Comments on the Buckling Assessment of the Oyster Creek Drywell Shell with Emphasis on the Determination of Capacity Reduction Factors

John W. Hutchinson
October 2, 2009

Fig. 3 Capacity reduction factors for spherical shells from slides presented to ACSR on February 2, 2007.

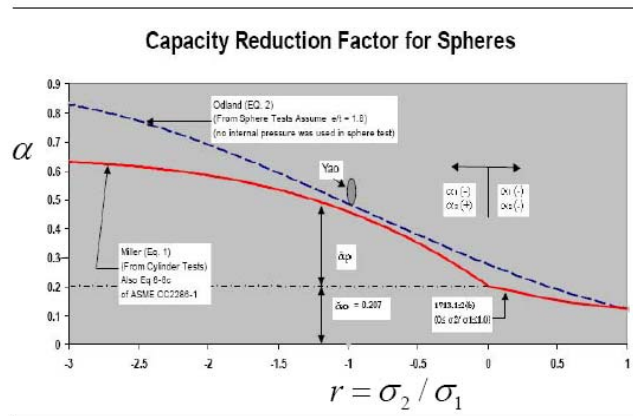
Another plot of capacity reduction factors as a function of r is included here in Fig. 3. This plot is Slide #26 of the AmerGen presentation to the ACRS of February 2, 2007. The lower (red) curve is the same as that plotted in Fig. 1 for CC 2286-1. The data range of the Yao tests has been plotted incorrectly in Fig. 3 (c.f. Fig.1). Four of the seven shells buckled below the prescription of CC 2286-1.

zero transverse membrane stress the approaches differ. For loading cases producing proportional transverse stress, a procedure evaluating α at the transverse stress of the applied load, as has been done in the drywell shell assessments, will underestimate α if $\sigma_2 < 0$ and overestimate α if $\sigma_2 > 0$ compared to the procedure that uses the transverse stress at buckling. (This follows because the magnitude of transverse buckling stress at the applied load is never greater than its magnitude at buckling and because α is a decreasing function of r , as seen in Figs. 1-3.) Since many of the loading cases involved in the drywell shell assessment have $\sigma_2 < 0$, it follows that this aspect of the procedure employed in the assessment is conservative compared to the proposed alternative. This observation must be tempered by the fact that the capacity reduction factor employed in these assessments based on CC-2286-1 in Fig. 3 or in (3) may not be conservative when $r < -0.5$.
